Title: Injection Pressure Regulator (IPR) Pigtail

Applies To: MaxxForce 07-09 and 2010 DT, 9, & 10 engine builds and later (ESN 3000000 to 3999999)

IPR KIT 1889325c94

Figure 2: IPR With new connector

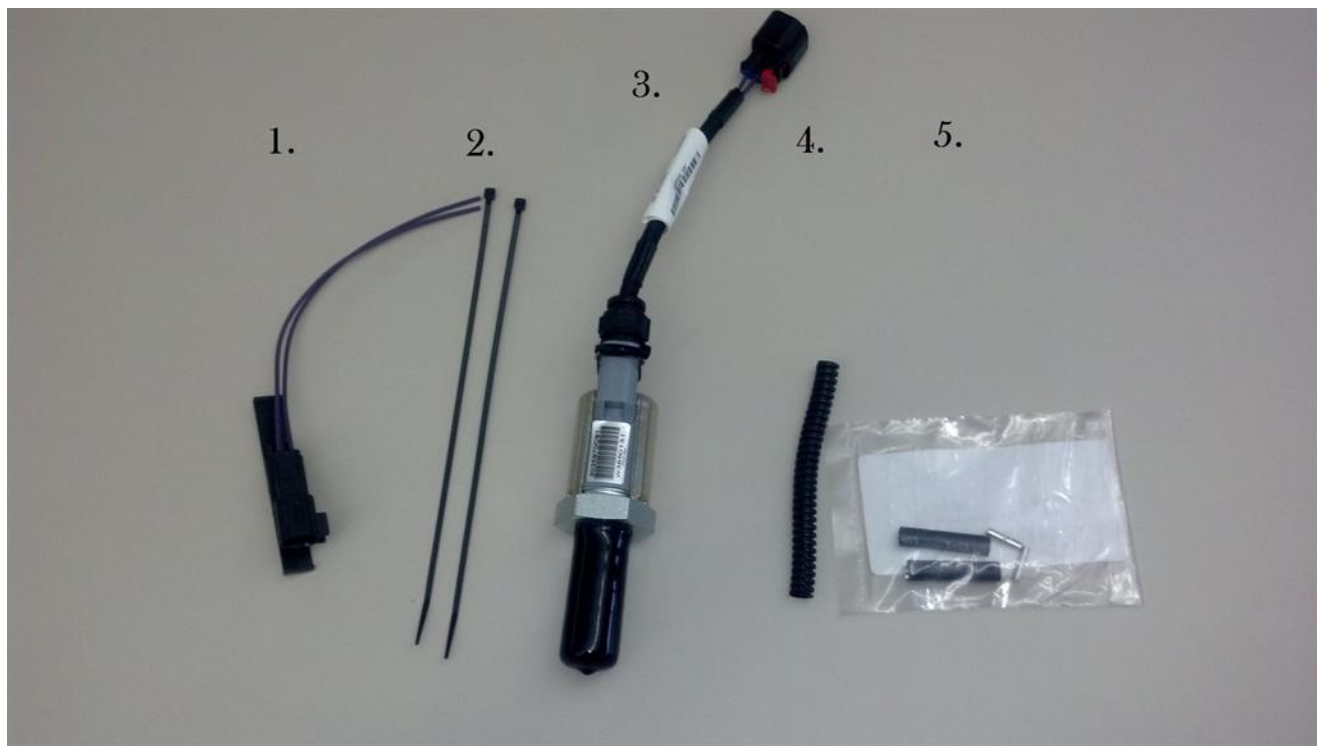
- A new IPR Kit has been released. The new style has a remote mounted connection 7 inches from the IPR valve (figure 2).
- **The connection at the IPR valve is no longer serviceable and disassembly should not be attempted (figure 2).**
- The kit includes a new IPR valve, IPR pigtail, zipties, butt connectors, convolute, and directions for installing the new IPR (figure 3).
- The IPR Solenoid needs to be clocked properly, refer to the included instruction sheet for proper installation.
- The new style IPR requires the use the new tool 12-800-01(see figure 4 below)
- Tool instructions are available on the Service Tool Resource Center (TL2900008).

1. Not servicable: Do not attempt to disconnect
2. Remote mounted connector.

Figure 5: IPR pigtail and IPR Valve showing the necessary bend in the wire to prevent future fretting.

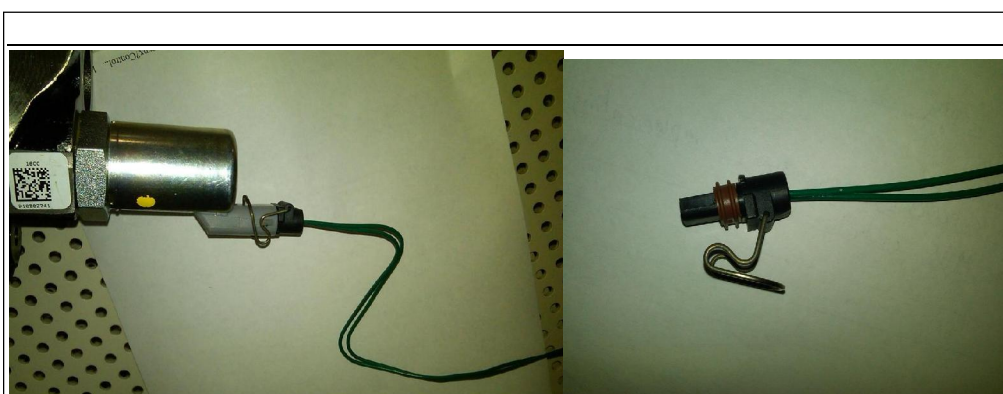
- IPR pin fretting increases resistance at IPR connection.

- Replace IPR valve and/or pigtail; leave generous length of wire to allow movement. The IPR pigtail service part must have a 90mm wire tail between the IPR connector and the wiring harness. See Figure 5 below.
 - Use a generous amount of Dielectric Grease.
